Re: Landfill Proposal by SITA on Allawuna Farm – Lots 9926, 4869, 5931 and 26934 Great Southern Highway, St. Ronan's, York, WA.

Submission on Planned Proposal - Allawuna Landfill Facility

Attention: Shire Planner

ALLAWUNA FARM LANDFILL LOCALITY PLAN

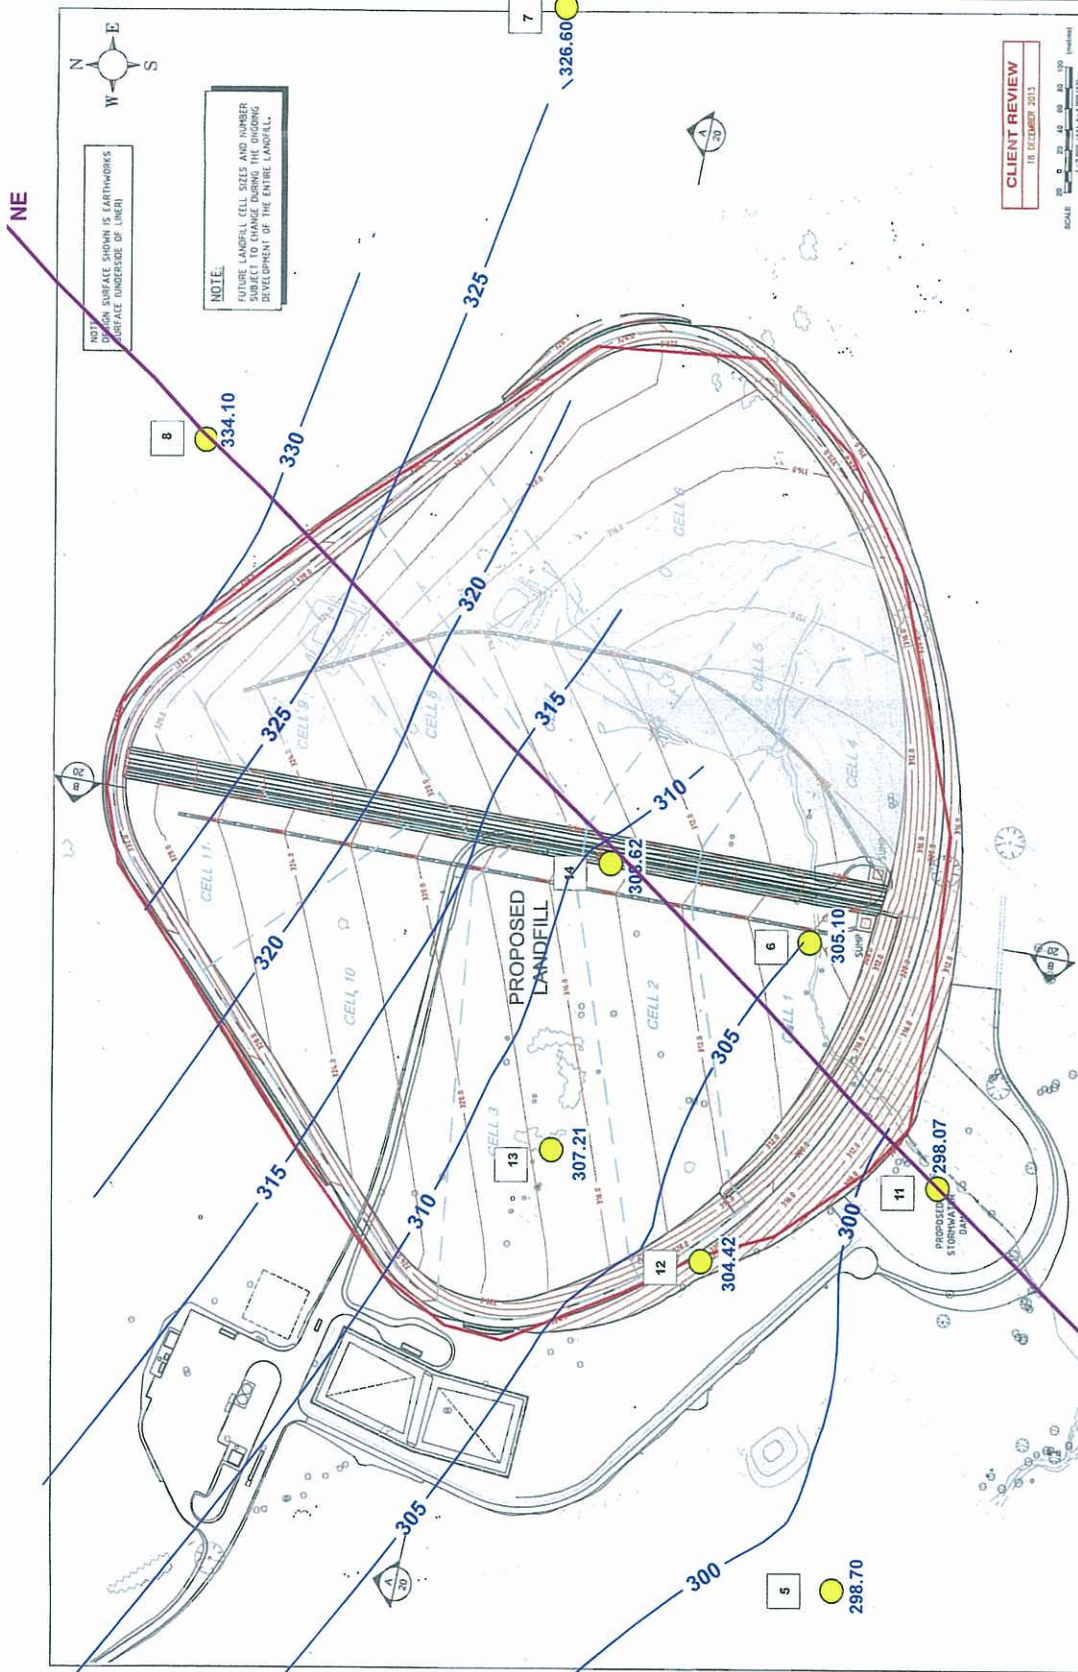
1. The groundwater elevations presented in Figure 2 of the Referral Document are incorrect, being too low by about 20 m or more, as a result of incorrect ground-surface elevations. For example, the ground elevation at monitoring bore MB06 is stated in Table 1 of the Document to be 283.35 m AHD, whereas the published topographic map shows ground elevation of about 307 m AHD at this location. The elevations of the bore collars (TOC) for monitoring bores MB09 to MB14 in Appendix 2 of the Works Approval Application appear to be correct. In Figure 1 of the present report, the elevations of the water levels in MB05 to MB08 have been calculated from map-derived ground elevations.

Figure 2

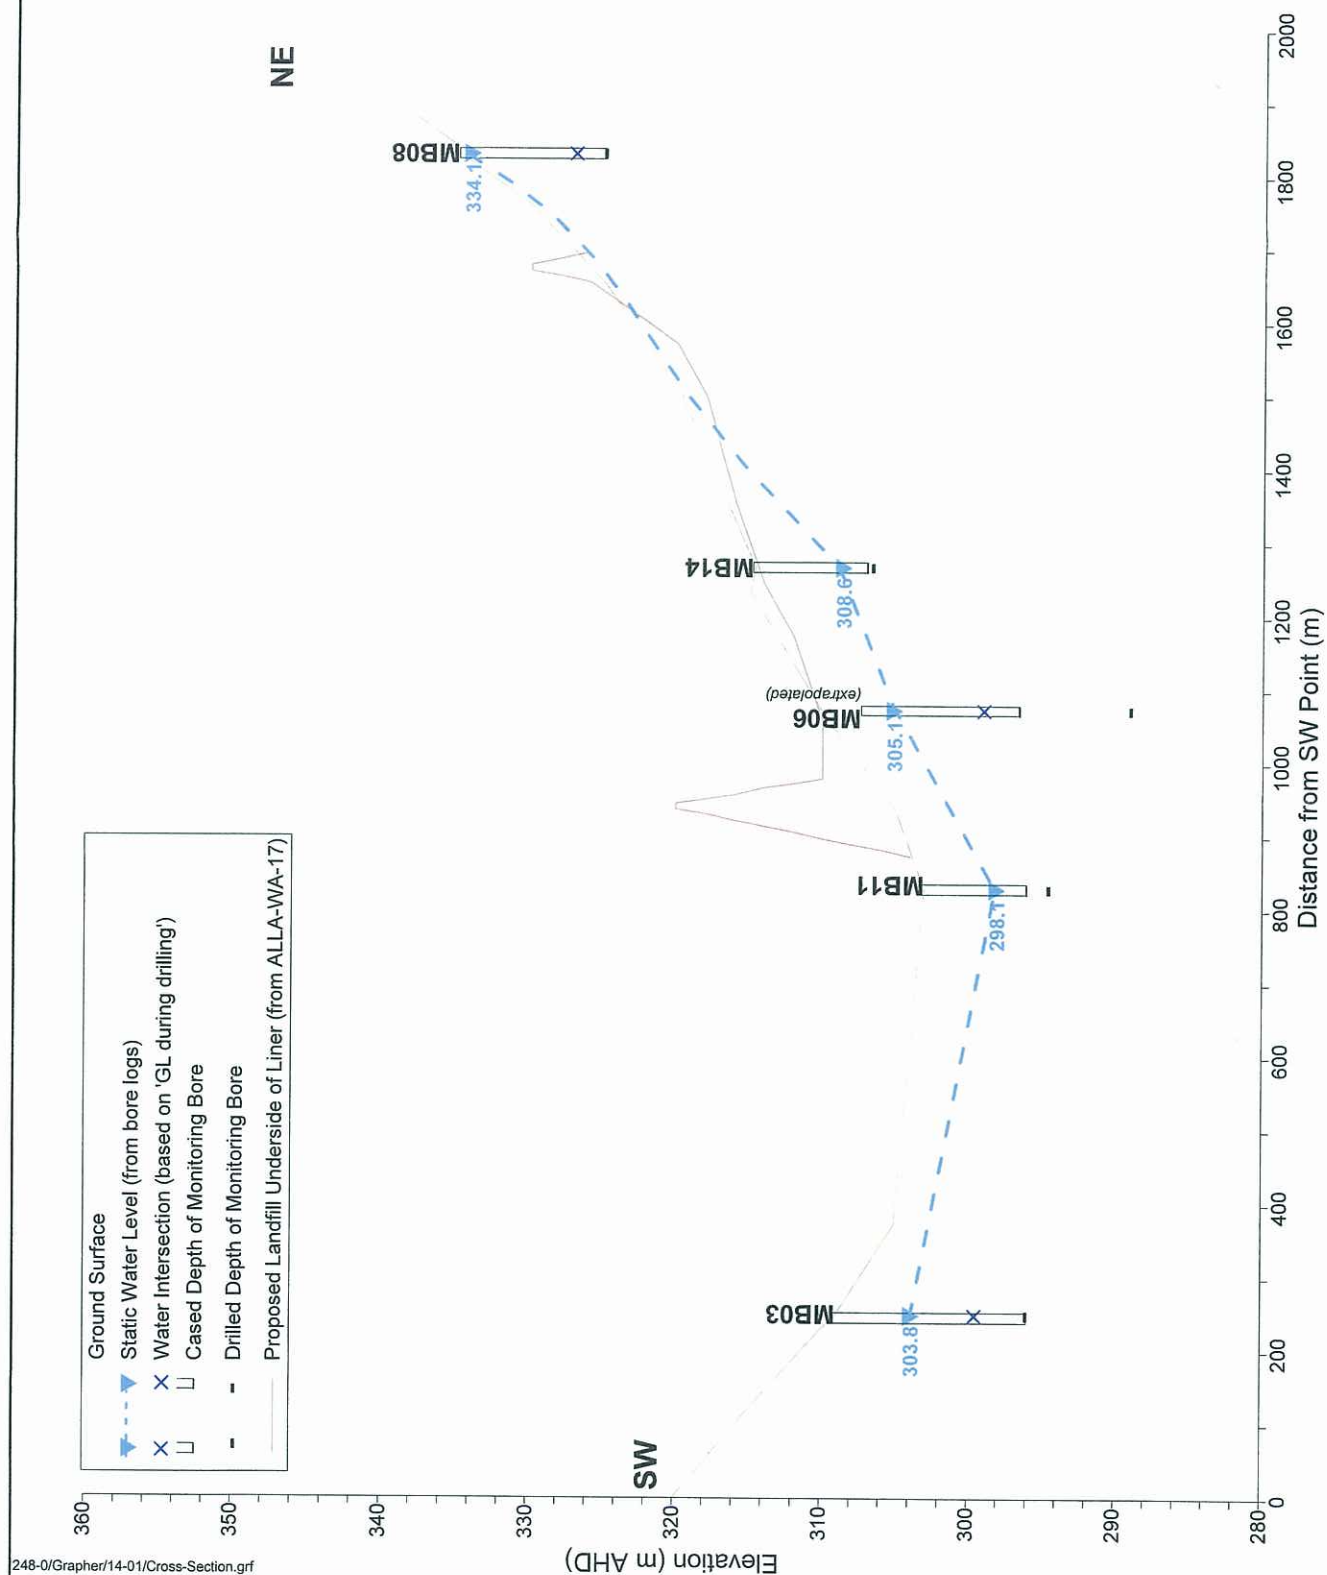
After excavation of the eastern half of the landfill site (cells 4 to 9), the base surface of the landfill will be as much as 3 m lower than the static water levels over the area indicated in Figure 2. It is noted that the depiction is based on extrapolated water-level data. It indicates that there is potential for static water levels to be locally higher than the base surface of the landfill, giving rise to hydraulic heads directed upwards on the landfill liner. This is understood to be undesirable.
